**UNITED STATES  
NUCLEAR REGULATORY COMMISSION**  
WASHINGTON, D.C. 20555-0001

June 12, 2019

**SUBJECT: SURRY POWER STATION, UNIT NOS. 1 AND 2 - ISSUANCE OF  
AMENDMENT NOS. 295 AND 295 TO ADOPT TSTF-490, REVISION 0, AND  
UPDATE ALTERNATIVE SOURCE TERM ANALYSES (EPID L-2018-LLA-0068)**

**Figure A.1 (from PNNL-18212, Revision 1) Bounding PWR Linear Heat Generation Rate and Limiting Segmented Power Histories for Stable (PWR History #6) and Short-Lived Releases (PWR History #4)**

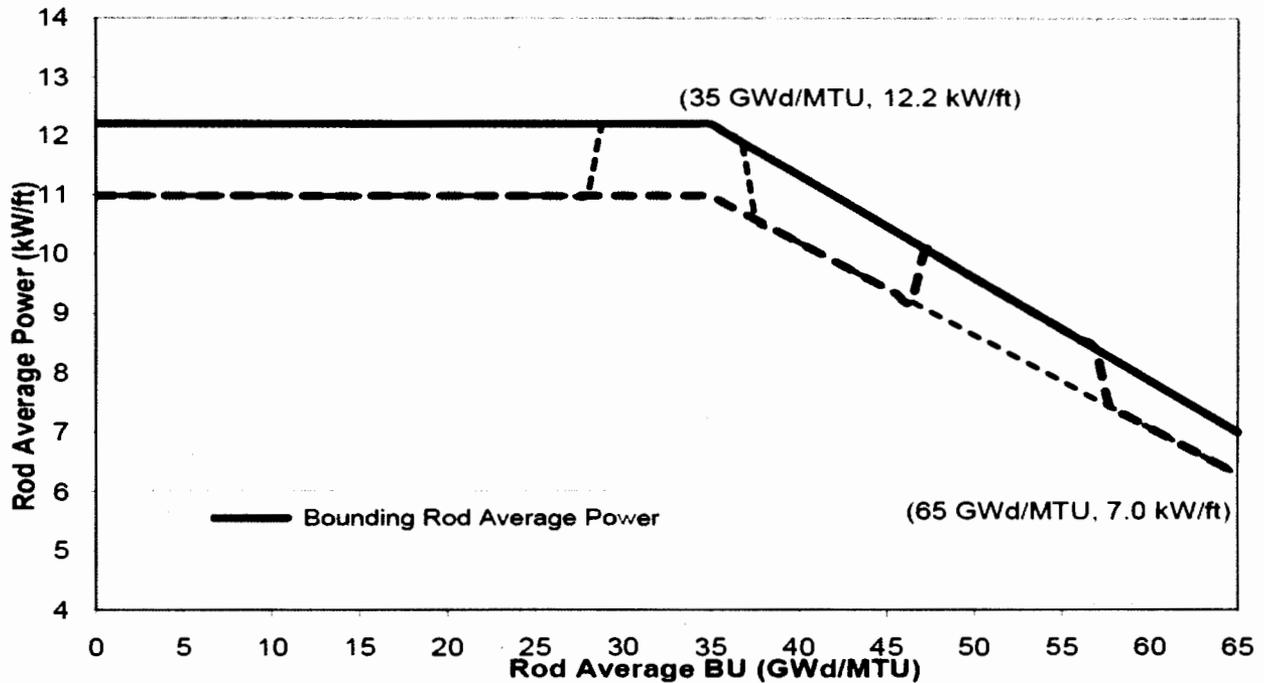
PNNL-18212, Revision 1 (Reference 32), includes new proposed fission gas gap fractions in Table 2.9 (the "Maximum" column) and a bounding curve of rod average power to rod average burnup for pressurized water reactors (PWRs) in Figure A.1, which are both reproduced below.

Surry proposed that the bounding fission gas gap fractions in PNNL-18212, Revision 1, be used for the licensing basis FHA in lieu of the site-specific fractions currently in use by the licensee. The licensee states that the reload design will be validated against the operating curve each reload. As described in PNNL-18212, Revision 1, the "maximum" gas gap fractions are rounded up from the highest calculated fission gas release from all BWR and PWR assembly configurations currently in use or proposed for use in the United States. These values represent a 95/95 probability/confidence level (accounting for uncertainties in the fission gas release model to bound empirical data) for rods operated up to the bounding rod power envelope. All values in the "maximum" gas gap fraction column are thus calculated from fuel bundles found to have higher (for that isotope) than the Surry 15x15 fuel rod design. Because the method used in PNNL-18212, Revision 1, is based on the analysis of fission gas gap fraction and is applicable to Surry's FHA analysis, the NRC staff finds it acceptable to use the "Maximum" column fission gas gap fractions from PNNL-18212, Revision 1, Table 2.9, for Surry FHA analysis up to the rod average power versus rod average burnup curve in Figure A.1.
